Access Compliance Report

Public Rights-of-Way

Intersection ID: 30248	Main Street: OLD_IRONSIDE_DR	Cross Street: WOLVERINE_CT	Location: SE
ADA ID: 768849B7DD2D	Ramp Type: PerpDiag	Initial Pass/Fail: Fail	Overall Compliance: No
		Severity Score: 50

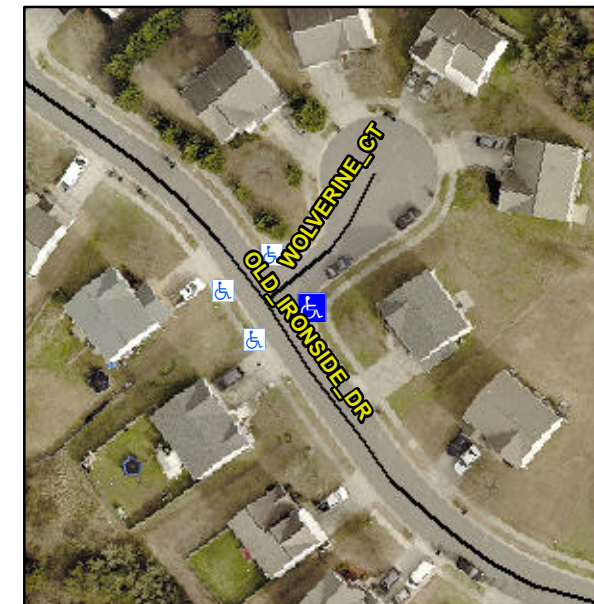
Not Found, R304.2.2, R304.5.3

Compliance	Description	Data	Compliance	Description	Data
N/A	Ramp Length (in)	46.0	No	Ramp Slope (%)	12.1
Yes	Ramp Width (in)	55.5	No	Ramp XSlope (%)	11.2
N/A	Flare Type LT	N/A	N/A	Flare Type RT	N/A
N/A	Flare Slope LT (%)	N/A	N/A	Flare Slope RT (%)	N/A
N/A	Flare Traversable LT?	N/A	N/A	Flare Traversable RT?	N/A
N/A	Landing Length (in)	N/A	N/A	DWS Provided?	N/A
N/A	Landing Width (in)	N/A	N/A	DWS Contrast?	N/A
N/A	Landing Slope (%)	N/A	N/A	DWS Length (in)	N/A
N/A	Landing X Slope (%)	N/A	N/A	DWS Full Width?	N/A
N/A	Landing Curb? (Y/N)	N/A	N/A	DWS Offset (in)	N/A
N/A	Shared Landing?	N/A			
N/A	Gutter Ponding?	N/A	N/A	Gutter Slope (%)	N/A
N/A	Gutter Lip Ht (in)	N/A	N/A	Gutter X Slope (%)	N/A
N/A	Painted X Walk1?	No	N/A	Painted X Walk2?	No
	X Walk 1 Direction	To NW		X Walk 2 Direction	To SW
N/A	X Walk 1 Width (in)	N/A	N/A	X Walk 2 Width (in)	N/A
	X Walk 1 Slope (%)	4.6		X Walk 2 Slope (%)	5.0
	X Walk 1 X Slope (%)	7.3		X Walk 2 X Slope (%)	6.0

Remove & Replace Curb Ramp With Two New Directional Ramps or Equivalent.
